Modification Recommended Service Note

N8940A - Autoranging System DC Power Supply, 80V, 170A, 5000W, 400 VAC

Serial Numbers: DE14290000 - DE15369999 without manufacturing ID Version "B"

5) SMT resistors R93/94 are located in red circle shown below:

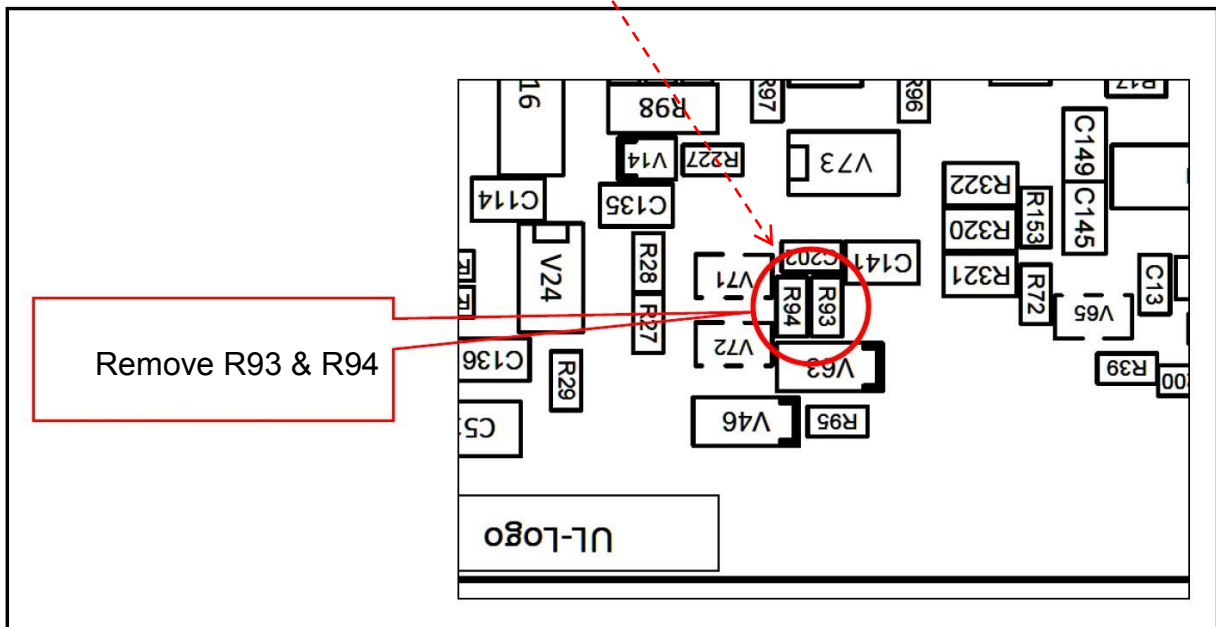
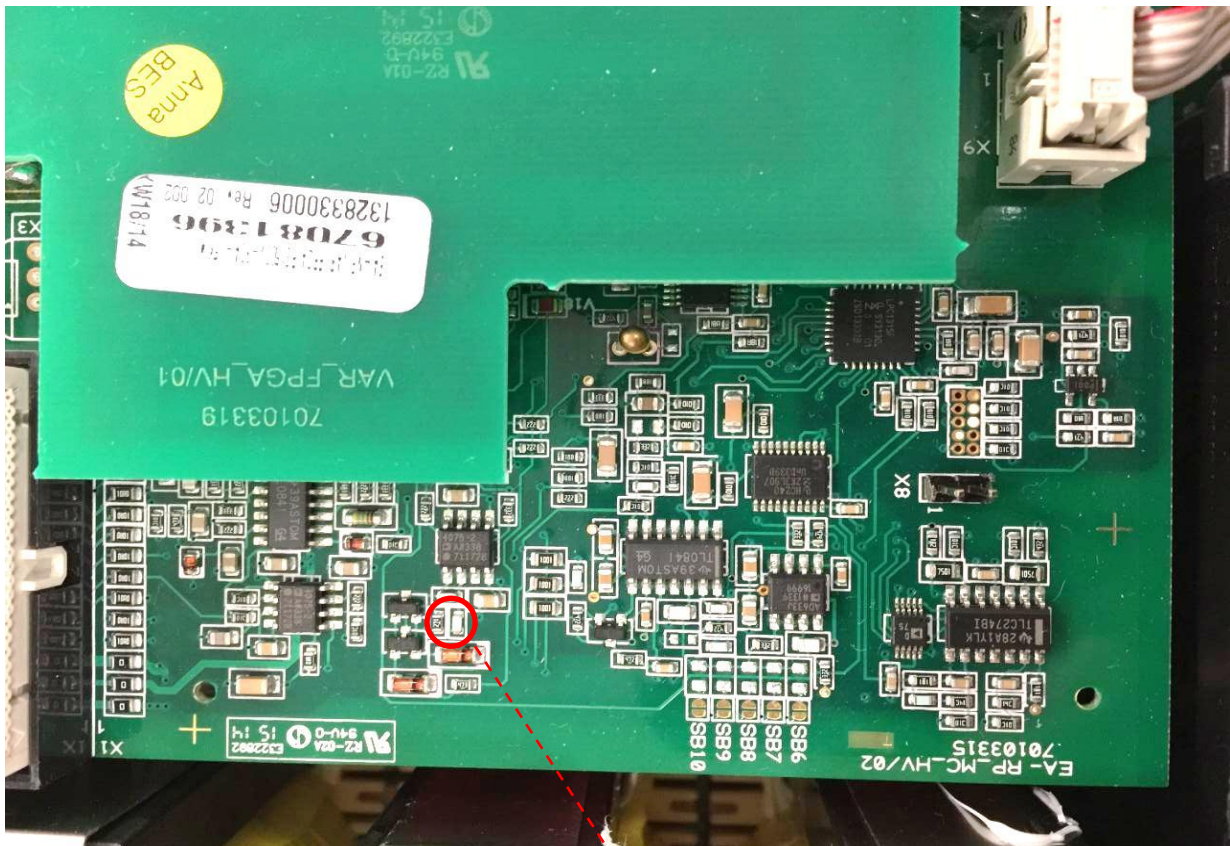
Resistors R93 and R94 must be removed, no replacement parts are required for modification.

Removal of two (2) surface mount resistors, R93 and R94, will correct this problem:

- 1) Remove acMains cable from power source.
- 2) Wait 5 minutes
- 3) Remove top cover from instrument.
- 4) In the 5kW units (viewed from the front of the unit), a small SMT assembly located at the right-rear of instrument will be readily visible (see below):

In the 10kW & 15kW units; although found in the same location, a black plastic cover will have to be removed to gain visibility and access to the SMT assembly. Plastic cover snaps-on and can be removed with a small screwdriver.

6) After removal of R93 & R94, re-install all covers. Instrument does NOT require recalibration after the removal of R93 & R94.

Suffix “B” added

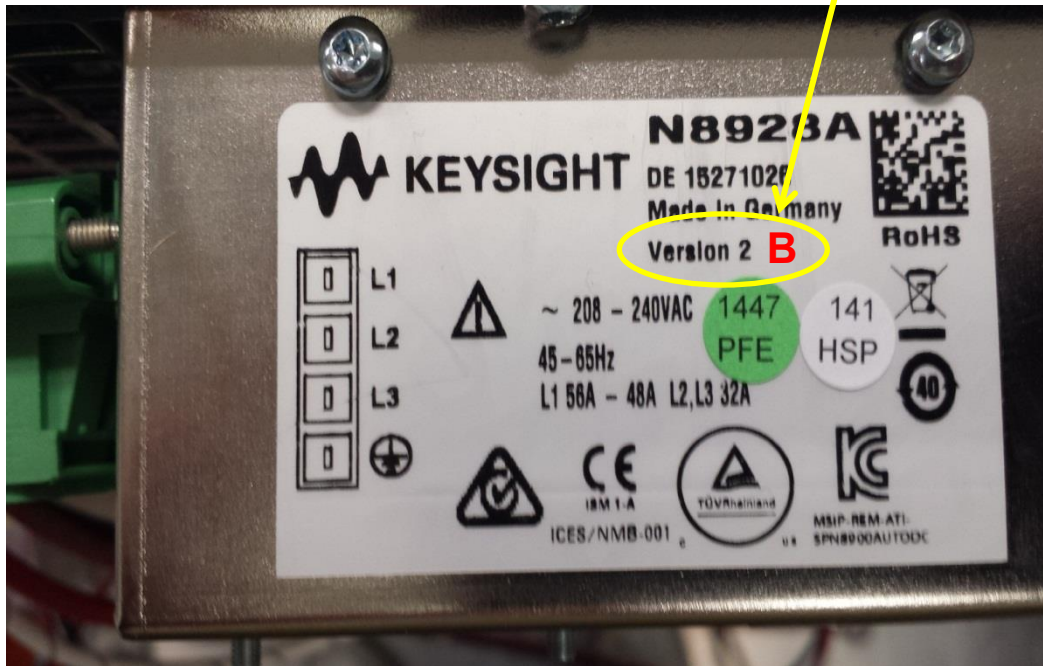
7) On the acMains label, on the rear of the instrument; use an indelible marker, to add the suffix letter “B” after the Version ID. This will assist in the tracking of modified instruments.
